Access Audit Site Report

Lyndon B Johnson State Park and Historic Site

**Inspection Date: 09/27/2022
Inspectors: Tanya Scheibe**

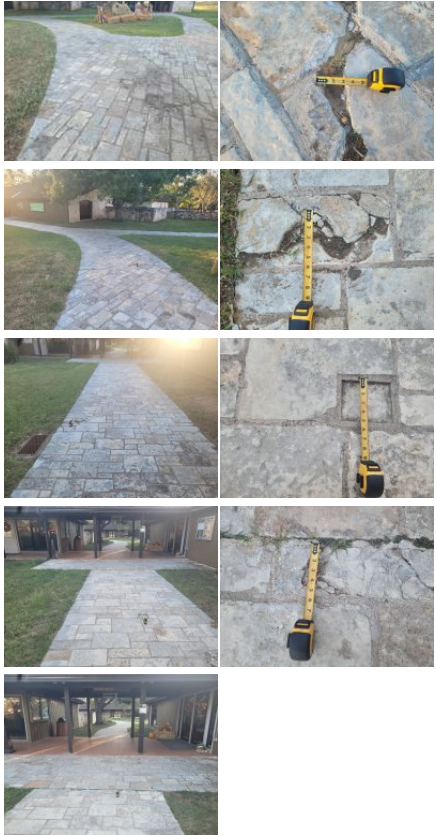
3	Visitor Center Complex: Visitor Center - Parking	[30.237504, -98.626873 3]	The parking sign is mounted too low. Parking space identification signs shall include the International Symbol of Accessibility complying with. Signs identifying van parking spaces shall contain the designation "van accessible." Signs shall be 60 inches minimum above the finish floor or ground surface measured to the bottom of the sign.	9 of 9 parking signs have "Violators Subject To Fine And Towing" signs lower than 60", but 9 of 9 R7-8 signs and 1 of 2 "Van Accessible" signs comply	Raise existing accessible parking related signs so lowest end of bottom sign is min 60" above ground level (AGL) measured from the surface of the stall.	2015 ABAAS Section: 502.6 2012 TAS Section: 502.6 2010 ADAS Section: 502.6	 	
4	Visitor Center Complex: Visitor Center - Exterior Accessible Route	[30.2374884, -98.626603 8]	The running slope of walking surfaces shall not be steeper than 1:20. The cross slope of walking surfaces shall not be steeper than 1:48.	2.3% along parking, 2.9% near garbage can, 2.3% at restroom building	Correct running slopes to max 5% and cross to max 2.08%.	2012 TAS Section: 403.3 2010 ADAS Section: 403.3

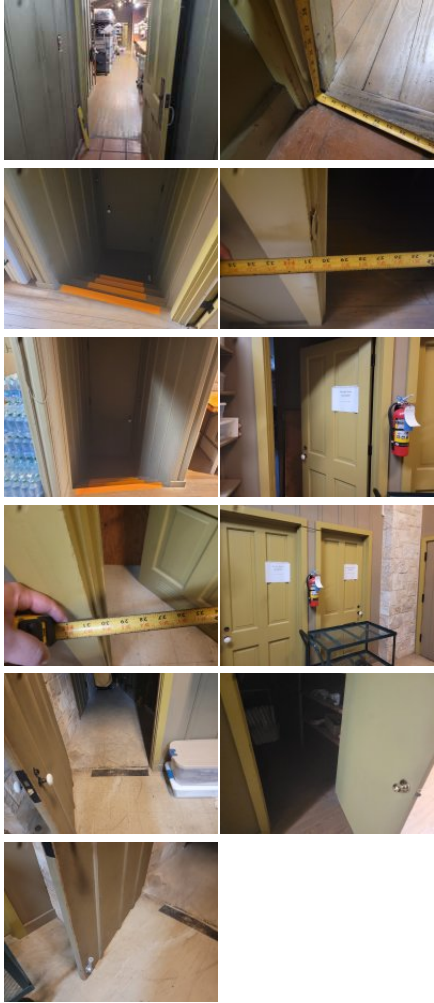
Finding Number	Area Description	Lat/Long	Finding	As Built	Recommendation	Citation	Photos	Figure
41	Visitor Center Complex: Visitor Center - Public Spaces	[30.2373962, -98.62659]	The drinking fountain has multiple violations. Drinking fountains must be on an accessible route that provides a 30 inch by 48 inch clear floor space centered on the low unit, allowing a forward approach. Spout outlets shall be 36 inches maximum above the finish floor or ground. Spout outlets of drinking fountains for standing persons shall be 38 inches minimum and 43 inches maximum above the finish floor or ground. The spout shall be located 15 inches minimum from the vertical support and 5 inches maximum from the front edge of the unit, including bumpers. The spout shall provide a flow of water 4 inches high minimum and shall be located 5 inches maximum from the front of the unit. The angle of the water stream shall be measured horizontally relative to the front face of the unit. Where spouts are located less than 3 inches of the front of the unit, the angle of the water stream shall be 30 degrees maximum. Where spouts are located between 3 inches and 5 inches maximum from the front of the unit, the angle of the water stream shall be 15 degrees maximum. Operable parts shall comply with applicable standards.	Drinking fountain at restroom building at Visitors Center - appears 1 of 2 fountains is missing, existing fountain is not compliant	Replace drinking fountain with a hi-lo bowl fountain.	2015 ABAAS Section: 403.5.1, 602.1 2012 TAS Section: 403.5.1, 602.1 2010 ADAS Section: 403.5.1, 602.1

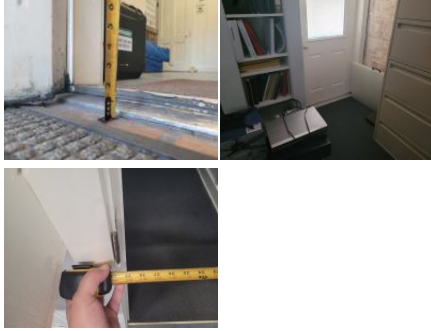
43	Visitor Center Complex: Visitor Center - Public Spaces	[30.2374153, -98.626585]	The operable part is positioned too high for either a side or front approach. Where a clear floor or ground space allows a parallel approach to an element and the side reach is unobstructed, the high side reach shall be 48 inches maximum and the low side reach shall be 15 inches minimum above the finish floor or ground. Where a forward reach is unobstructed, the high forward reach shall be 48 inches maximum and the low forward reach shall be 15 inches minimum above the finish floor or ground.	New vending machine (not fully installed yet) has credit card swipe at 60.5" AFF	Remount operable parts to be in reach range of 15" min to 48" max.	2015 ABAAS Section: 308.1 2012 TAS Section: 308.1 2010 ADAS Section: 308.1

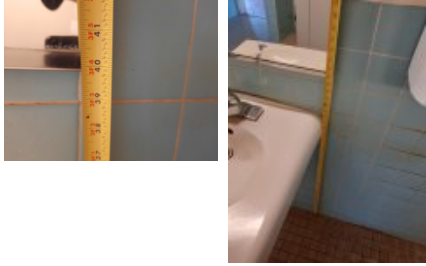
Finding Number	Area Description	Lat/Long	Finding	As Built	Recommendation	Citation	Photos	Figure
61	Visitor Center Complex: Visitor Center - Restroom Building Men's Restroom	[30.23738, -98.62663]	The mirror is mounted too high. Mirrors must have the bottom edge of the reflecting surface a maximum of 40 inches above the floor if above a sink or counter. Mirrors not located above lavatories or countertops shall be installed with the bottom edge of the reflecting surface 35 inches maximum above the finish floor or ground.	Bottom edge of mirror at 40.5"	Lower mirror so bottom reflective surface is max 40" AFF and 74" at the top.	2015 ABAAS Section: 603.3 2012 TAS Section: 603.3 2010 ADAS Section: 603.3		
62	Visitor Center Complex: Visitor Center - Restroom Building Men's Restroom	[30.23738, -98.62663]	Where a high forward reach is over an obstruction, the clear floor space shall extend beneath the element for a distance not less than the required reach depth over the obstruction. The high forward reach shall be 48 inches (1220 mm) maximum where the reach depth is 20 inches (510 mm) maximum. Where the reach depth exceeds 20 inches (510 mm), the high forward reach shall be 44 inches (1120 mm) maximum and the reach depth shall be 25 inches (635 mm) maximum. Where a clear floor or ground space allows a parallel approach to an element and the high side reach is over an obstruction, the height of the obstruction shall be 34 inches (865 mm) maximum and the depth of the obstruction shall be 24 inches (610 mm) maximum. The high side reach shall be 48 inches (1220 mm) maximum for a reach depth of 10 inches (255 mm) maximum. Where the reach depth exceeds 10 inches (255 mm), the high side reach shall be 46 inches (1170 mm) maximum for a reach depth of 24 inches (610 mm) maximum.	Soap dispenser at 48.5" with reach over sink	Lower soap dispenser to max 44" above the finished floor (AFF) for a forward reach over counter.	2015 ABAAS Section: 308.2.1, 308.3.2 2012 TAS Section: 308.2.1, 308.3.2 2010 ADAS Section: 308.2.1, 308.3.2

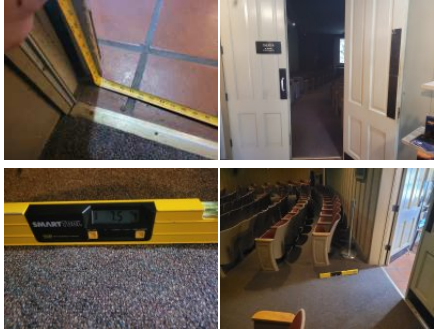
72	Visitor Center Complex: Visitor Center - Restroom Building Women's Restroom	[30.2373958, -98.626579 5]	The grab bar height and/or spacing fails. Grab bars must be mounted between 33" and 36" to the top of the gripping surface. There must be 1.5" of clearance between the grab bar and the wall. There must be a minimum of 1.5" of clearance below and minimum 12" above the grab bar to any dispenser or other obstruction.	Auto flush wall unit with button is above rear grab bar and reduces space to 1" between it and bar	Remove inactive auto flush sensor to provide required grab bar clearance.	2015 ABAAS Section: 609.3, 609.4 2012 TAS Section: 609.4, 609.3 2010 ADAS Section: 609.3, 609.4

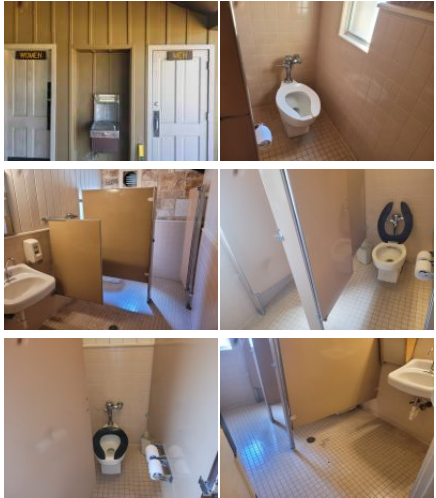
75	Visitor Center Complex: Visitor Center - Restroom Building Women's Restroom	[30.2374028 , -98.626594 3]	The compartment door is located too far from the partition or wall. The door shall be located in front of the clear space and diagonal to the water closet. Where located in the front partition, the door opening shall be 4 inches maximum from the side wall or partition farthest from the water closet. Where located in the side wall or partition, the door opening shall be 4 inches maximum from the front partition. Toilet compartment doors shall not swing into the minimum required compartment area.	stall door 8.25" from wall	Rehang stall door to be max 4" from adjacent stall partition and on the stall wall farthest from the toilet.	2015 ABAAS Section: 604.8.1.2 2012 TAS Section: 604.8.1.2 2010 ADAS Section: 604.8.1.2

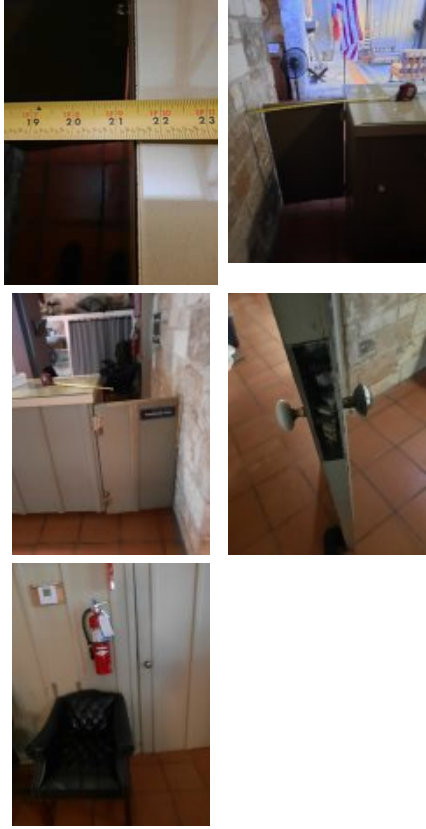
89	Visitor Center Complex: Visitor Center - Exhibit Hall	[30.237705, -98.6260166]	Minimum maneuvering clearances at doors and gates shall comply with 404.2.4. Maneuvering clearances shall extend the full width of the doorway and the required latch side or hinge side clearance. The bottom 10 inches on the push side must be smooth and free of obstructions (hold open devices). Opening hardware must be mounted between 30 and 44 inches above the floor or ground.	South entry doors - loose floor mat on pull side, hold open devices on both doors, both doors - glass starts 8.5" agl	For all doors along the public circulation route, secure rug in door clearance to prevent trip hazard. For all doors along the public circulation route, provide kick plate on push side of door from floor to 10" AFF. For all doors along the public circulation route, remove door holder to provide a smooth surface on the push side of door from floor to 10" AFF.	2010 ADAS Section: 404.2.3, 404.2.7, 404.2.4, 404.2.11, 404.2.11 Exception

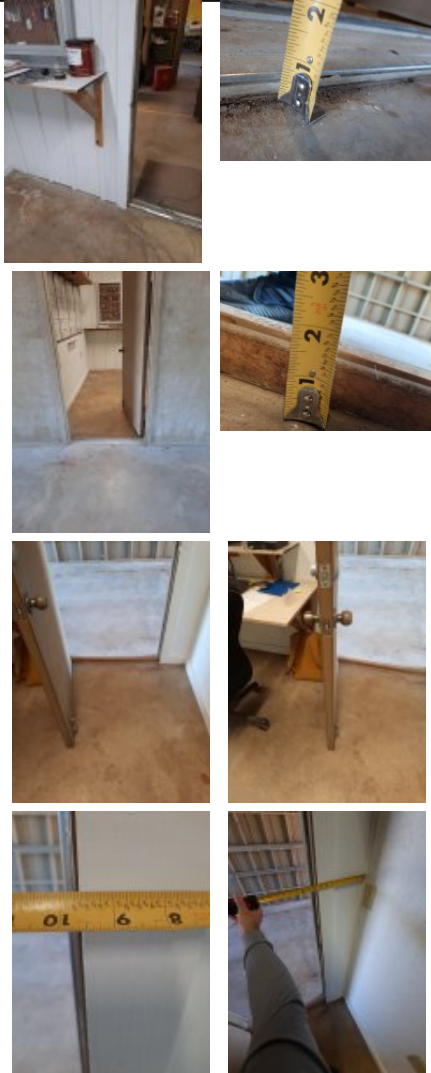
123	Visitor Center Complex: Visitor Center - Women's Restroom In Visitor Center	[30.23747, -98.62618]	An item or items project more than 4 inches into the circulation path. Wall-mounted objects that have leading edges between 27 inches and 80 inches from the floor must not project more than 4 inches into the circulation path. Protruding objects that extend to the floor or within 27 inches of the floor are cane detectable and are therefore not hazardous. Where it is necessary or desirable to have objects protrude from the wall, a manner of cane detection must be provided.	Hand dryer protrudes 9"	Relocate protruding objects or place cane detectable warning or bollard at foot of item.	2015 ABAAS Section: 307.2 2012 TAS Section: 307.2 2010 ADAS Section: 307.2

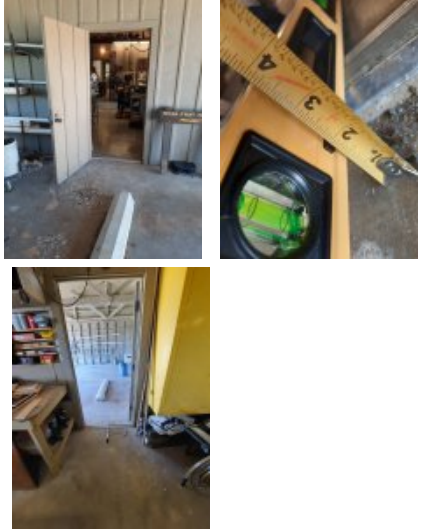
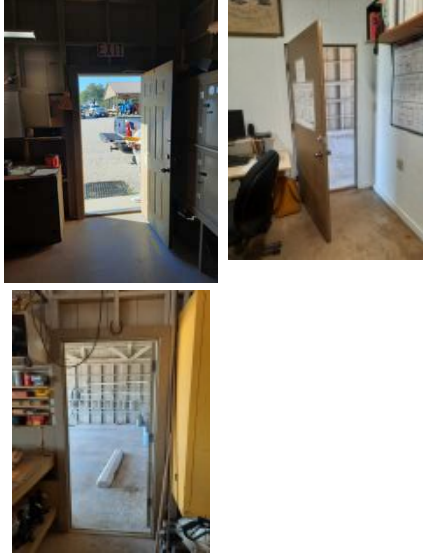
128	Employee Areas: Maintenance	[30.2368654, -98.642352 2]	The restroom sign does not comply with one or more applicable requirements for the location, height, and properties of the sign.	Lacks signage	Acquire and mount signage, including Braille and raised lettering mounted on wall, latch side of door, 48" to baseline of lowest character and 60" to baseline of highest character.	2015 ABAAS Section: F216.2, 703.1, 703.2, 703.5, 703.6 2012 TAS Section: 216.2, 703.1, 703.2, 703.5, 703.6 2010 ADAS Section: 216.2, 703.1, 703.2, 703.5, 703.6

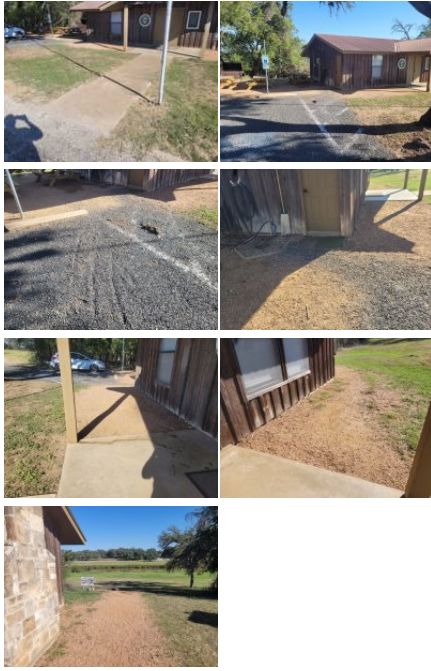
Finding Number	Area Description	Lat/Long	Finding	As Built	Recommendation	Citation	Photos	Figure
142	Employee Areas: Maintenance	[30.23691, -98.64244]	The operable part is not accessible because there is not adequate clear floor space for either a forward or side approach. The clear floor or ground space shall be 30 inches minimum by 48 inches minimum.	Lacks clear floor space (CFS) at microwave	Remove, or relocate storage in CFS at fixtures and operable parts along the AR.	2015 ABAAS Section: 305.3 2012 TAS Section: 305.3 2010 ADAS Section: 305.3		
143	Employee Areas: Maintenance	[30.23691, -98.64244]	The operable part is positioned too high for either a side or front approach. Where a clear floor or ground space allows a parallel approach to an element and the side reach is unobstructed, the high side reach shall be 48 inches maximum and the low side reach shall be 15 inches minimum above the finish floor or ground. Where a forward reach is unobstructed, the high forward reach shall be 48 inches maximum and the low forward reach shall be 15 inches minimum above the finish floor or ground.	Light switch and ice machine controls exceed reach range	Remount operable parts to be in reach range of 15" min to 48" max.	2015 ABAAS Section: 308.1 2012 TAS Section: 308.1 2010 ADAS Section: 308.1

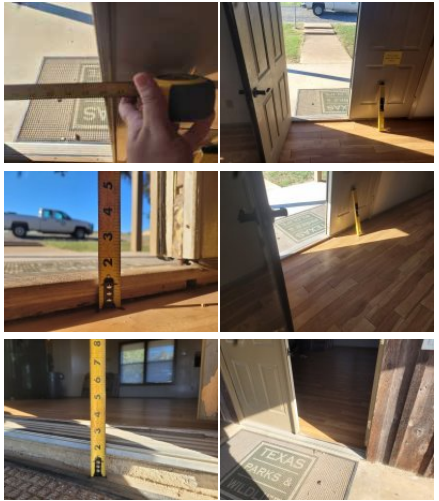
148	Resource Education Center: Resource Ed Ctr - Parking	[30.2375252, -98.6417836]	The parking sign is mounted too low. Parking space identification signs shall include the International Symbol of Accessibility complying with. Signs identifying van parking spaces shall contain the designation "van accessible." Signs shall be 60 inches minimum above the finish floor or ground surface measured to the bottom of the sign.	Violation sign at 53" agl	Raise existing accessible parking related signs so lowest end of bottom sign is min 60" above ground level (AGL) measured from the surface of the stall.	2015 ABAAS Section: 502.6 2012 TAS Section: 502.6 2010 ADAS Section: 502.6

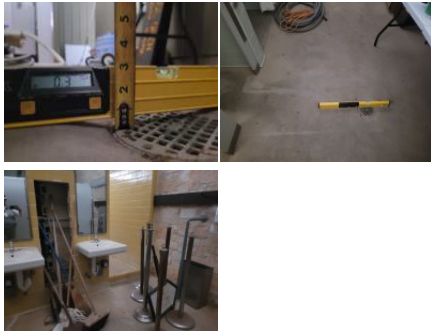
Finding Number	Area Description	Lat/Long	Finding	As Built	Recommendation	Citation	Photos	Figure
247	Aquatic Complex: Aquatic - Men's Locker Room	[30.2359992, -98.6376431]	The accessible route contains running slopes greater than 5 percent and cross slopes greater than 2 percent across the width of the walk and has not been constructed as a ramp (i.e. handrails, wheel guides, etc.). When the slope in the direction of travel of any walk exceeds 1 unit vertical in 20 units horizontal (5-percent slope), it must be constructed as ramp. Surface cross slopes must not exceed one unit vertical in 48 units. Horizontal (2-percent slope).	2.3% slope at floor drain	Correct or repair slope to max 2.08% in restroom.	2015 ABAAS Section: 403.3 2012 TAS Section: 403.3 2010 ADAS Section: 403.3		
248	Aquatic Complex: Aquatic - Men's Locker Room	[30.2359764, -98.6376504]	Transfer type shower compartments shall be 36 inches (915 mm) by 36 inches (915 mm) clear inside dimensions measured at the center points of opposing sides and shall have a 36 inch (915 mm) wide minimum entry on the face of the shower compartment. Clearance of 36 inches (915 mm) wide minimum by 48 inches (1220 mm) long minimum measured from the control wall shall be provided.	36.75" wide by 36.5" deep	Renovate transfer shower to compliant 36" by 36" clear inside dimension.	2015 ABAAS Section: 608.2.1 2012 TAS Section: 608.2.1 2010 ADAS Section: 608.2.1

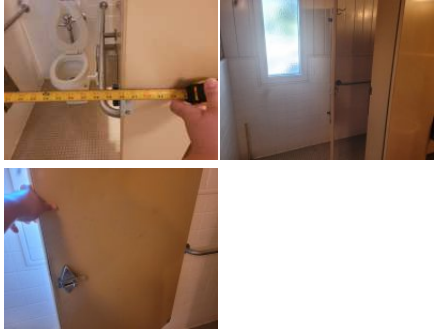
315	Park Elements: Ball Field	[30.235376, -98.642194 6]	The restroom sign does not comply with one or more applicable requirements for the location, height, and properties of the sign.	Women's ballfield restroom - sign on door, lacks Braille and raised characters	Replace sign with one of contrasting colors that includes Braille, raised characters, and the symbol of accessibility and mount on the wall, latch side of the door, 48" to the baseline of the lowest character and 60" to the baseline of the highest character.	2015 ABAAS Section: F216.2, 703.1, 703.2, 703.5, 703.6 2012 TAS Section: 216.2, 703.1, 703.2, 703.5, 703.6 2010 ADAS Section: 216.2, 703.1, 703.2, 703.5, 703.6

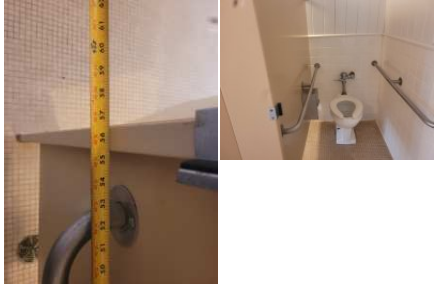
326	Park Elements: Ball Field	[30.2353617 , -98.642179 7]	Minimum maneuvering clearances at doors and gates shall comply with 404.2.4. Maneuvering clearances shall extend the full width of the doorway and the required latch side or hinge side clearance. The sweep period for doors with closers shall be adjusted so that from an open position of 70 degrees, the door will take at least 3 seconds to move to a point 3 inches from the latch, measured to the leading edge of the door. Exterior doors are recommended to be maintained at 8.5 lbf as a smart practice. Force is to be measured at the operating hardware or 30 inches from the hinges, whichever is greater.	Men's ballfield restroom exterior door - wall back in pull side clearance, garbage can in push side clearance, 11# push, closes fast	For all doors along the public circulation route, provide required maneuvering clearance on push and pull side of doors. For all doors along the public circulation route, inspect, adjust, and maintain closing speed on door closers. For all doors along the public circulation route, inspect, adjust, and maintain 8.5 lbf to open exterior doors as a smart practice.	2010 ADAS Section: 404.2.3, 404.2.7, 404.2.4, 404.2.11, 404.2.11 Exception
